# IREDELL COUNTY HEALTH DEPARTMENT

PERMIT # 206041

## SEPTIC IMPROVEMENT PERMIT / AUTHORIZATION TO CONSTRUCT / OPERATION PERMIT / EXISTING SYSTEM

Subject: Notice of Intent to Revoke/Suspend Riverwalk Lot #1 557 Stewart Rock Rd
**(specify name/location)** Improvement Permit/Construction Authorization

AS BUILT SKETCH

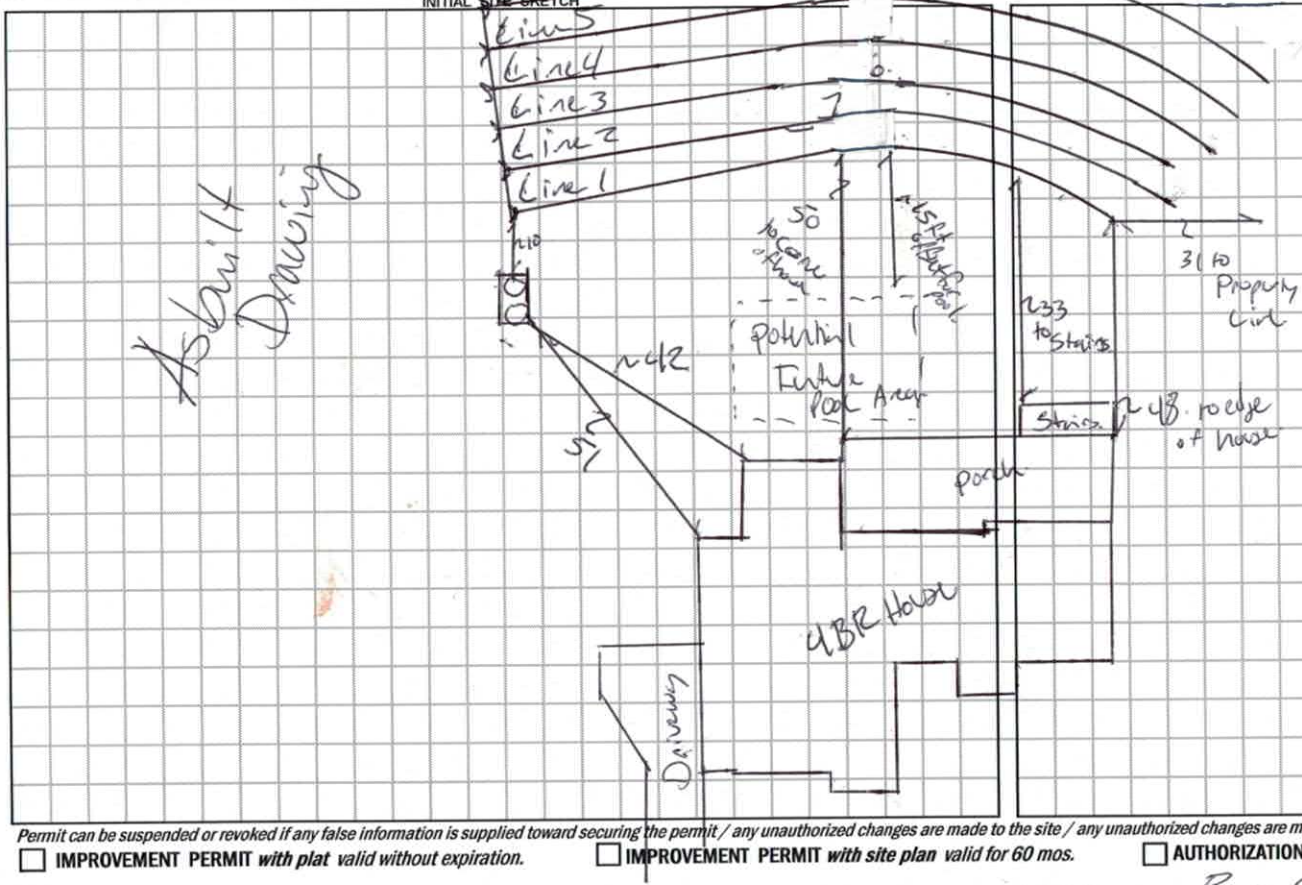
Installed in 6 Lines.
Line 1: 58
Line 2: 70
Line 3: 66
Line 4: 70
Line 5: 66
Line 6: 70

## IMPROVEMENT PERMIT / AUTHORIZATION TO CONSTRUCT / OPERATION PERMIT / EXISTING SYSTEM

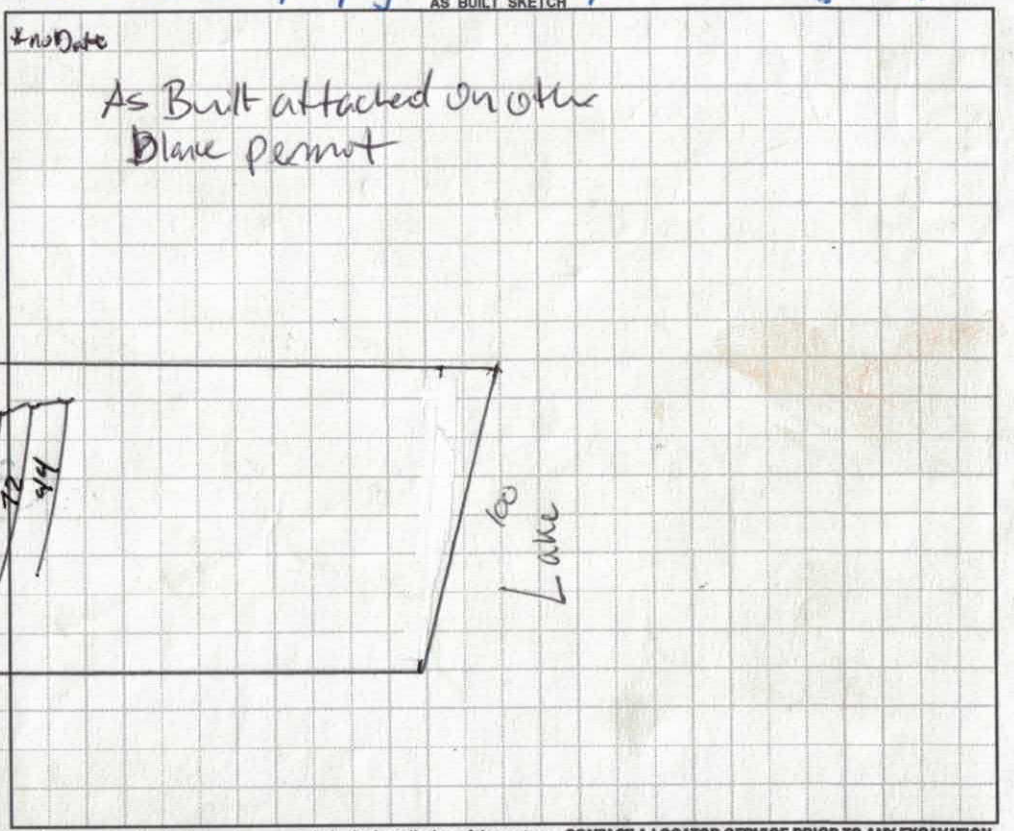
Comments / Conditions: Install septic system on the contour of the land to utilize serial distribution. Do not exceed max depth of 36 inches. Do not drive, park, pave, grade or build anything over drainfield area.
4/17/17: House box (including deck + landing is ≈ 61.5' deep

Consequently, the updated maximum pool dimension is revised to 23' x 40' to accomodate for the house box.
* Recommend pumping out the septic tank every 3-5 years*

## IMPROVEMENT PERMIT / AUTHORIZATION TO CONSTRUCT / OPERATION PERMIT / EXISTING SYSTEM

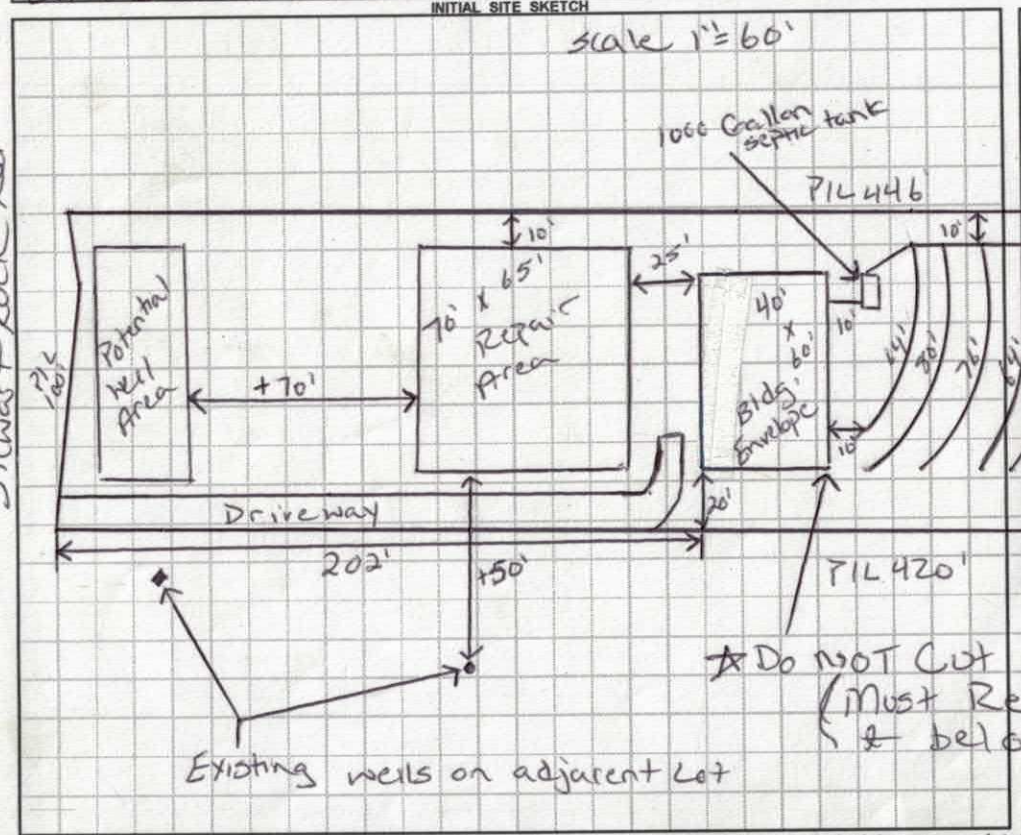
Comments / Conditions: IMPROVEMENTS ONLY; Submit floor plan prior to issuance of CA. Install a 25% Reduction system on contour with serial distribution.

★ Do NOT Cut Below This Point. ★ (Must Remain Natural at & below this elevation)

DO NOT ISSUE BUILDING PERMIT!
FLOOR PLAN STILL NEEDED!
